## Shire of Denmark Town Planning Scheme No. 3 Amendment No. 144

## SCHEDULE OF SUBMISSIONS

### Lantzke Road TPS3/SA144 Amendment and Structure Plan

#### Submissions Received from Public & Government Agencies

**LOCAL STRUCTURE PLAN**  
 LOT 3 MCLEAN ROAD AND LOTS 4, 5, 6 & 7 LANTZKE ROAD, DENMARK

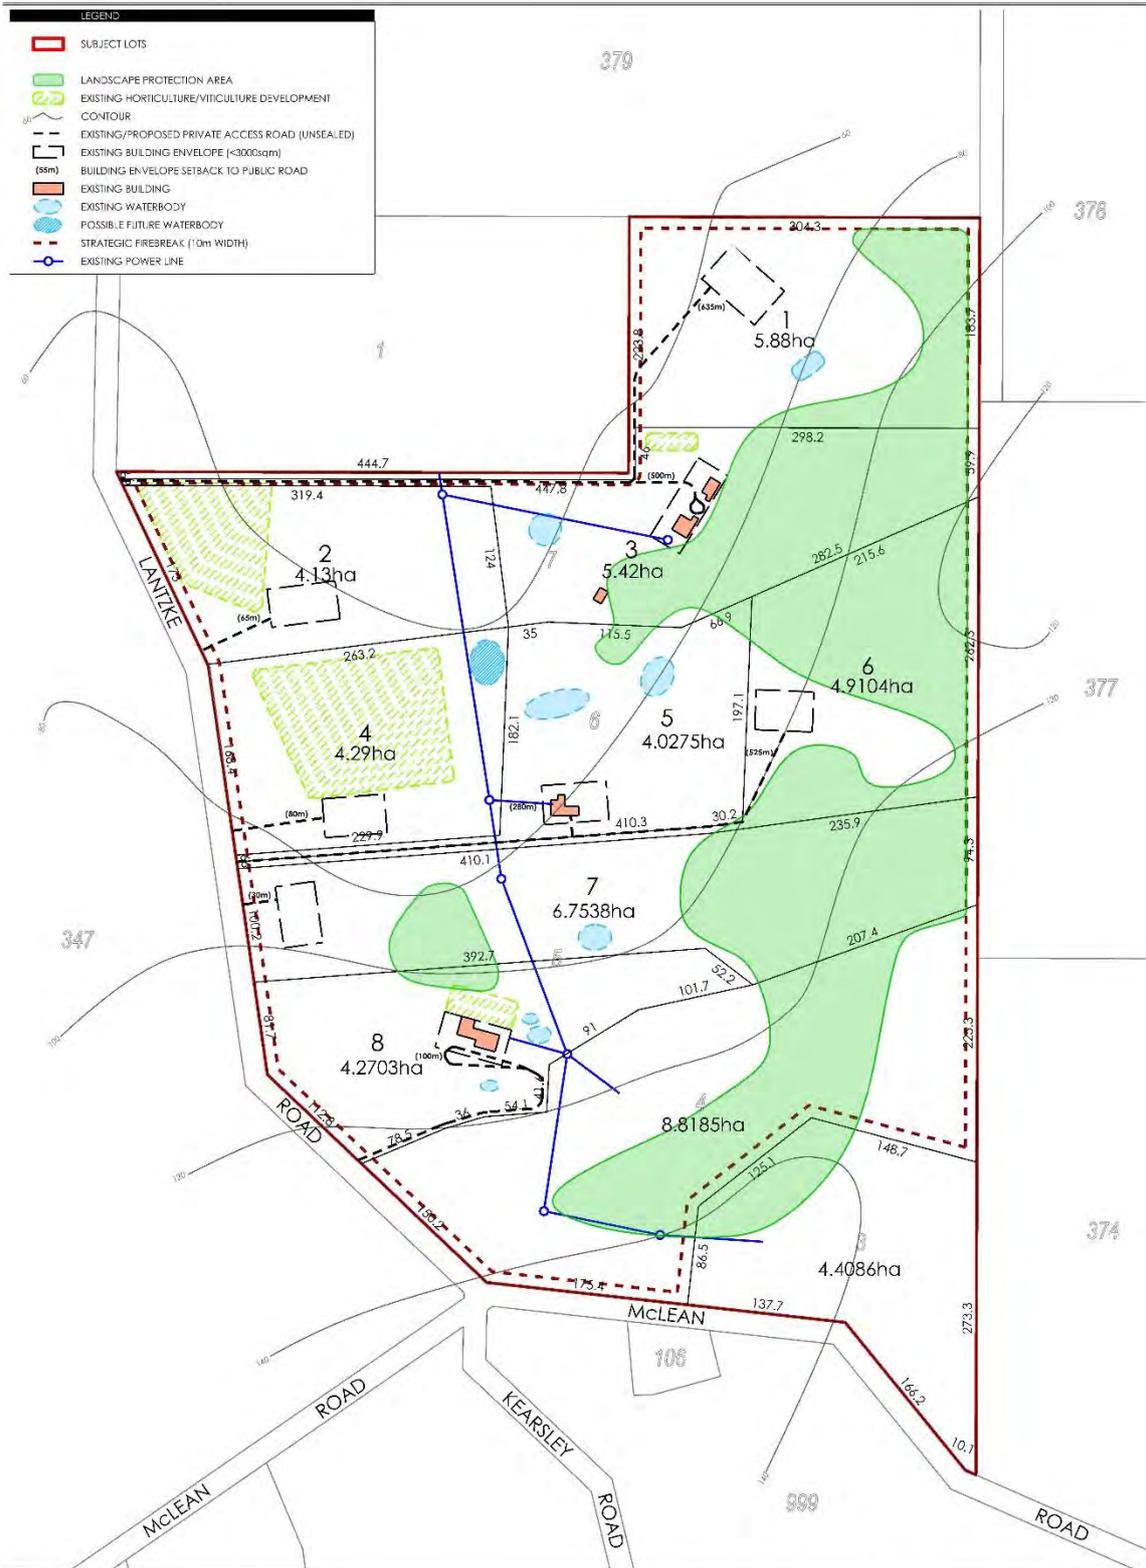
S3	999 Investments PO Box 495 DENMARK WA 6333	<p>No objection to the proposed Amendment 144.</p> <p>However the following to be included –</p> <p>Both documents, in relation to Lantzke Road indicate the future upgrading of this access road by way of a financial contribution at subdivision stage. The 'structure plan' needs also to show this.</p> <p>I refer to the deemed provisions part 16 (1)C(V1) which states 'The extent to which the plan provides for the coordination of key transport and other infrastructure'.</p> <p>In relation to the proposed structure plan the following will eventuate upon subdivision approval –</p> <p>Existing Lots                    3 Proposed Additional Lots    5 1 Existing tourist facility    1 1 Existing Holiday Accommodation 1</p> <p>Based on 8 car movements per day this (10) will generate 80 car movements per day from the existing and proposed lots or uses.</p> <p>Lantzke Road is substandard in its current construction. Sight distance, width, drainage have always been and remain a current concern. Recently Lantzke Road has become a thoroughfare and tourist route from Scotsdale and</p>	<p>Upheld (in part)</p> <p>Whilst the role that Lantzke Road plays in the wider road network is acknowledged, the decision to change the designation to a neighbourhood connector road in the Shire's road hierarchy should be made strategically, as part of the review of the Local Planning Strategy.</p> <p>Contributions from subdividers toward the upgrade of Lantzke Road will be made based on the increase in traffic that each subdivision brings to the road and the need to improve the road condition and standard accordingly. Individual subdividers cannot be expected to contribute to a neighbourhood connector road standard as the premise for identifying it as a neighbourhood connector results from the fact that it takes traffic from the wider area.</p> <p>The structure plan should also detail that a contribution to upgrading Lantzke Road will be required at the time of subdivision.</p>

G7	<p>Dept of Fire &amp; Emergency Services 363 Oxford Street MT HAWTHORN <u>REDACTED</u></p>	<p>I refer to your letter dated 11 December 2020 regarding the submission of a Bushfire Management Plan (BMP) (Revision 3), prepared by Working on Fire and dated 26 July 2017 as part of the above Structure Plan.</p> <p>It should be noted that this advice relates only to <i>State Planning Policy 3.7 Planning in Bushfire Prone Areas</i> (SPP 3.7) and the <i>Guidelines for Planning in Bushfire Prone Areas</i> (Guidelines).</p>	<p>Noted</p> <p><u>Bushfire Management Plan (BMP)</u> Although the standard methodology has not been used the mapping is still easily interpreted and understood.</p> <p><u>BAL Inputs</u> The BMP included in the documentation is a ‘condensed version’ only. A full version has been sought from the company.</p>

The BMP was prepared in 2017 and does not use the appropriate methodology as per the appendices in the Guidelines. The Vegetation Classification Map should be separate to the BAL Contour Map as per Appendix 3.

There is no photographic evidence or slopes provided to support the BAL Contour Plan conclusions.

There appears to be future building envelopes in BAL-40.

The Guidelines state that the strategic planning proposal should be located in areas with the least possible risk of bushfire. Proposed Lots 1, 3, 6 and 9 have an extreme BHLand are not supported.

Battle-axe legs are to be avoided in bushfire prone areas. They are only considered an acceptable solution 'where no alternative exists'. The BMP is not adequately justified that there is no alternative.

The BMP states that a 92,000L dual purpose tank with 10,000L reserved for firefighting purposes will be installed to comply with Element 4. This is not supported. The acceptable solution is for a 50,000L strategic tank to be installed for firefighting purposes for the following reasons:

With the removal of Lot 7 from the proposal only the building envelope on proposed Lot 6 would have a portion within the BAL-40 classification. However there still appears to be room to develop a single house in a compliant location and support is recommended.

Only one battle axe leg is proposed (accessing proposed Lot 6) and this is an extension of an existing driveway. If the intensification of the area is to be supported there appears to be little other option than to entertain a battle axe leg in this case.

A contribution toward a 50,000l centrally located tank may be appropriate in addition to 10,000l of dedicated fire-fighting water. This can be achieved at the time of subdivision as the scheme amendment and structure plan do not bind the Shire or WAPC in this regard.

<p>BMP and has identified several issues that need to be addressed prior to support of the proposal (refer to the tables above).</p>	<p>allowing a battle-axe leg subdivision and dedicated fire-fighting water these do not seem to be fatal flaws in the proposal.</p> <p><b>As the BMP forms an appendix to the structure plan it should be updated to reflect the above issues.</b></p>
--	--	--	--

Attachment B

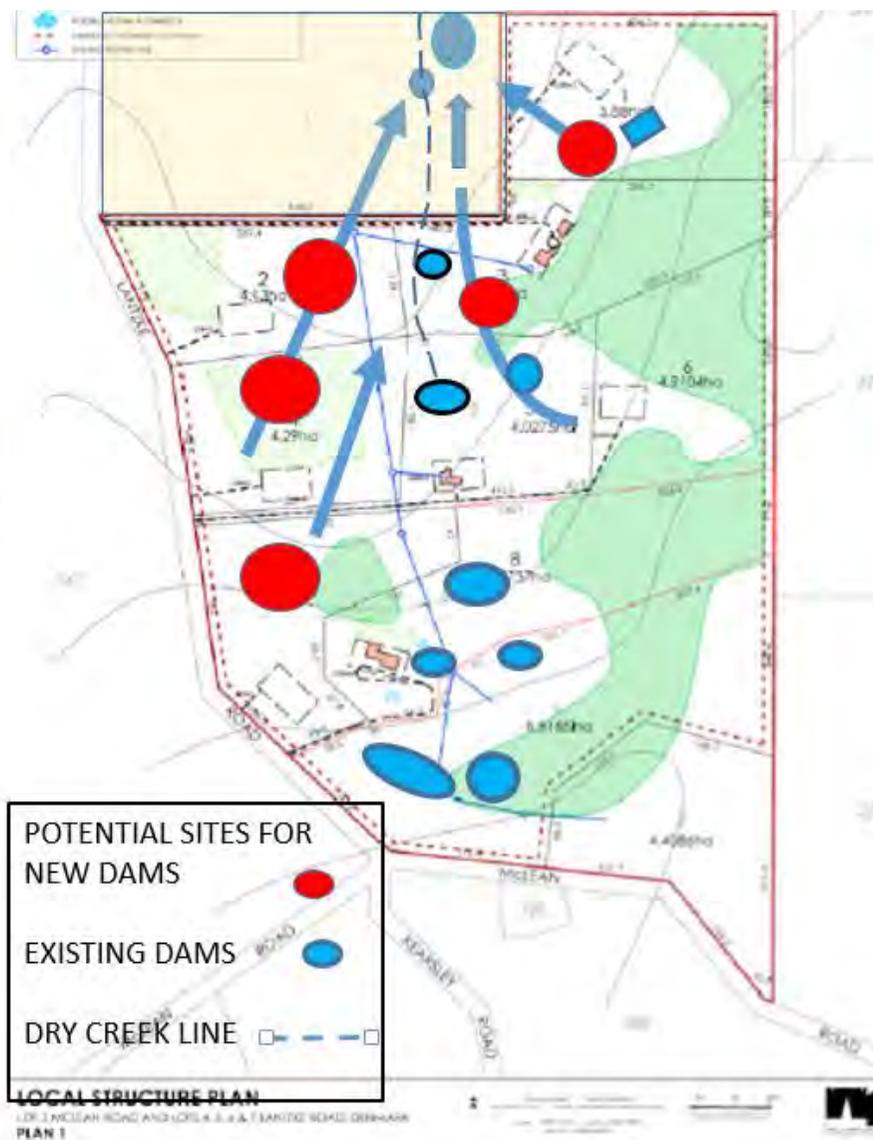
Our house was built in *REDACTED* with a 12 metre setback from the boundary adjacent to the road. When it was built it was the only house on Lantzke Road, which was then a no through road. (See Attachment B)

This statement is clearly untrue. Every vehicle which passes our house in dry conditions deposits dust onto it, which remains there until washed off the roof into the drinking water supply.
